TECHNICAL BULLETIN
Bell Helicopter **TEXTRON**

No. 222U-99-88

MODEL AFFECTED: Model 222U

SUBJECT: TAIL ROTOR GEARBOX P/N 222-042-001-007,
-101 AND -103 CONFIGURATION CHANGE
AND UPGRADE

TAIL ROTOR GEARBOX

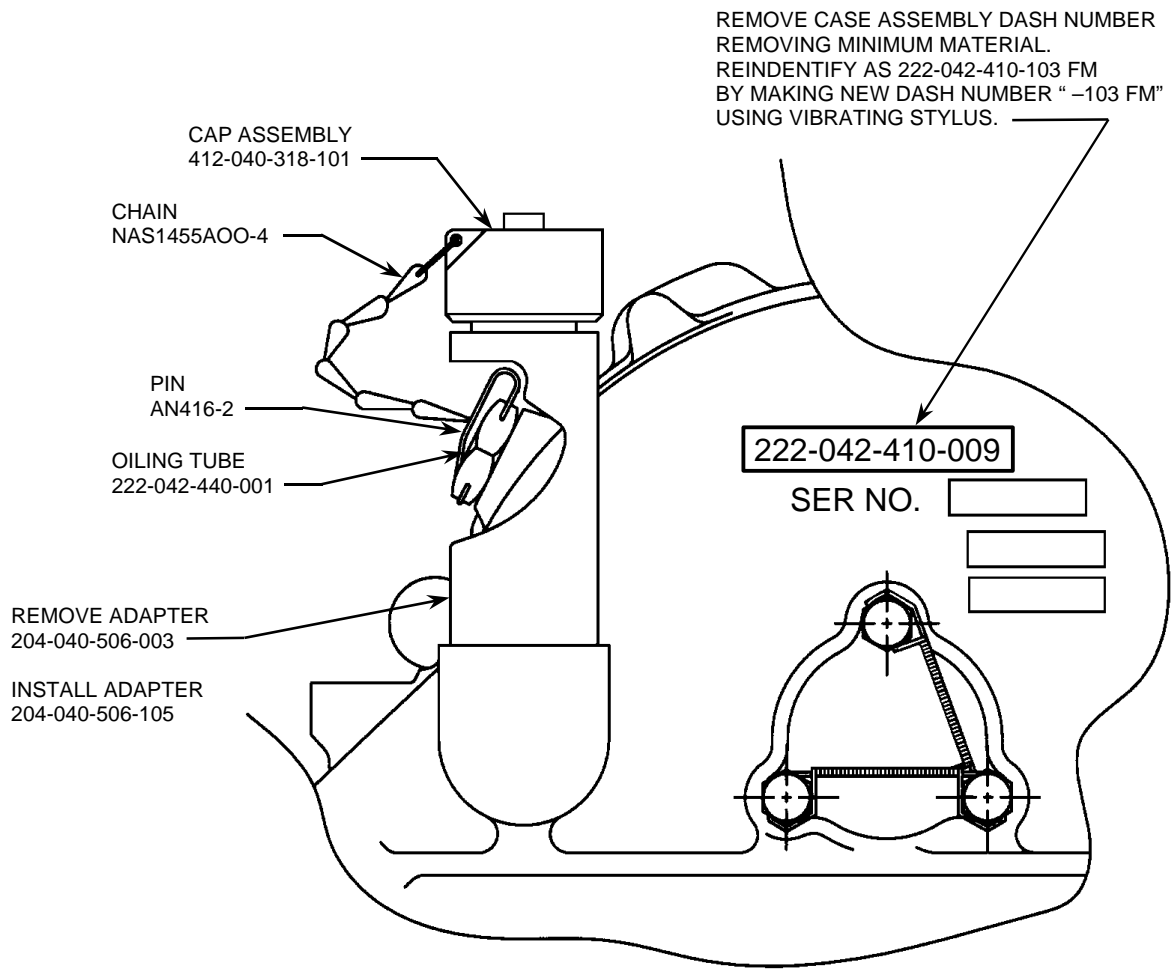
PART I Modification of P/N 222-042-410-009 tail rotor gearbox case assembly to accept the new filler cap with improved water exclusion characteristics.

Part I of this bulletin provides information for the modification of 222-042-410-009 tail rotor gearbox case assembly to accept the new oil filler cap assembly P/N 412-040-318-101. This new oil filler cap will improve water exclusion characteristics of all earlier delivered tail rotor gearbox assemblies.

7. Cool P/N 204-040-506-105 oil filler adapter.
8. Coat the internal diameter of case boss with epoxy primer (C-204).

9. Insert new oil filler adapter into case boss.
10. Ensure adapter is fully seated in tail rotor gearbox case. Wipe excess primer from adapter and gearbox case.

11. Using P/N AN416-2 pin, secure chain on oil filler cap assembly P/N 412-040-318-101 to one of the holes in the hex head of P/N 222-042-440-001 oiling tube. Refer to Figure 1.
12. Reidentify tail rotor case assembly 222-042-410-009 as follows:

- a. Remove case assembly -009 dash number by removing minimum material. Reidentify as 222-042-410-103 FM by making new dash number "-103 FM" using vibrating stylus. The serial number of a field modified part will not be altered or changed. Refer to Figure 1.
 - b. Chemical film treat reworked area as per BHT-ALL-SPM, Table C-1, Item B-2. Touch-up using primer (C-204 or C-246) and topcoat using paint (C-245).
 - c. Reidentify case assembly as 222-042-410-103 FM in the historical records.
13. Service tail rotor gearbox. Refer to BHT-222U-MM-2.
 14. Install the tail rotor gearbox fairings. Refer to BHT-222U-MM-7.
 15. Make entry in the helicopter historical records indicating compliance with PART I of this Technical Bulletin.
